SL20/25 Leg Extension

Service Bulletin

Bulletin #	Revision	Distribution	Date	Author
ST01041701	Original	<input checked="" type="checkbox"/> Domestic <input type="checkbox"/> International	April 17, 2001	Taylor

Subject: Redesigned Tibia Adjustment Mechanism

SL20/25 Leg Extension - Range Limiter

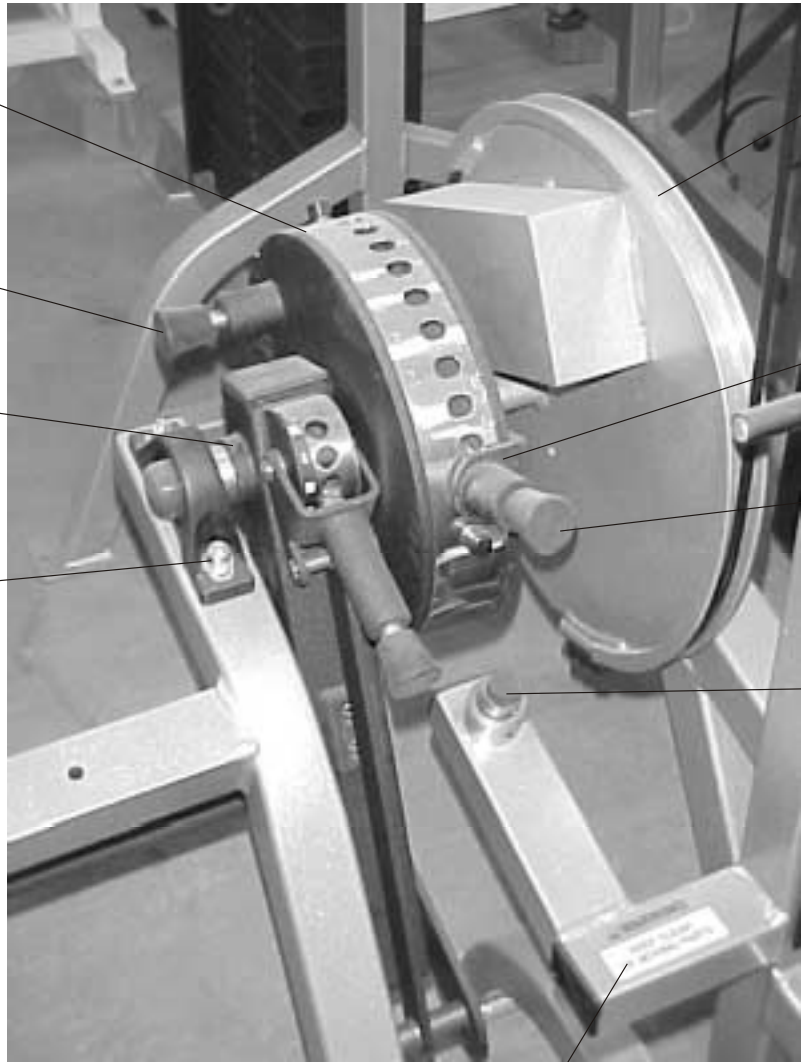
OLD STYLE Tibia (Kicker)
 SL25-S0005-0000
 SL35-S0004-0000
 SL45-S0011-0000
 ST25-S0005-0000

PARTS FOR TIBIA ADJUSTMENT MECHANISM

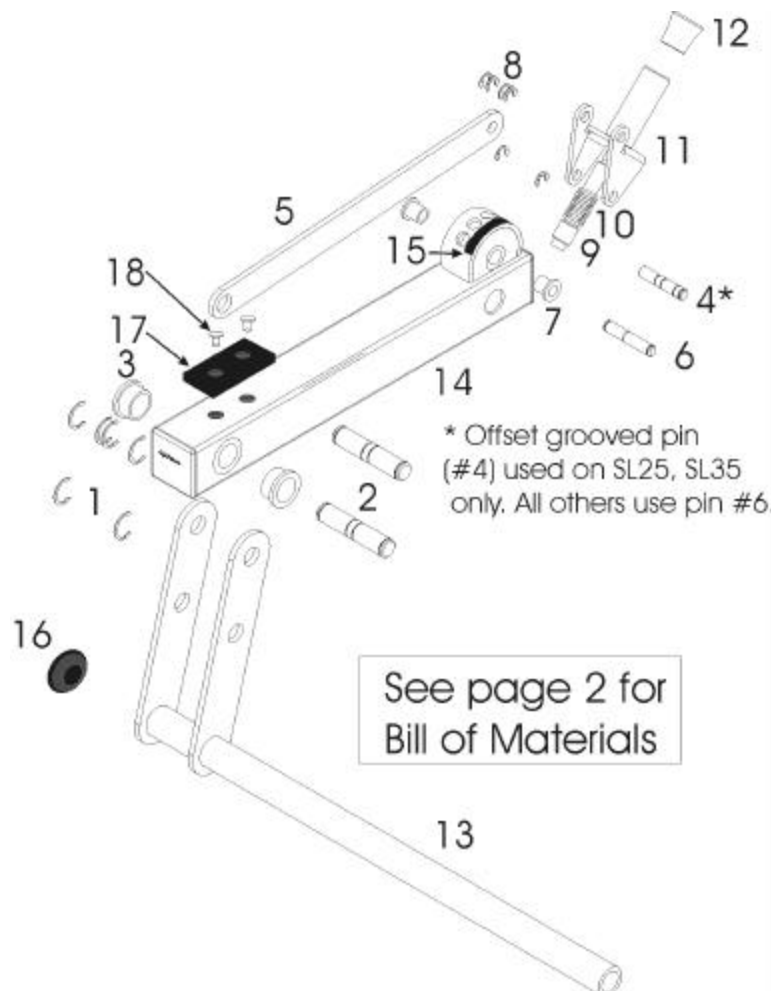
A redesigned tibia adjustment mechanism is factory installed on models and serial numbers as indicated above. Use exploded view and the corresponding parts list as necessary.
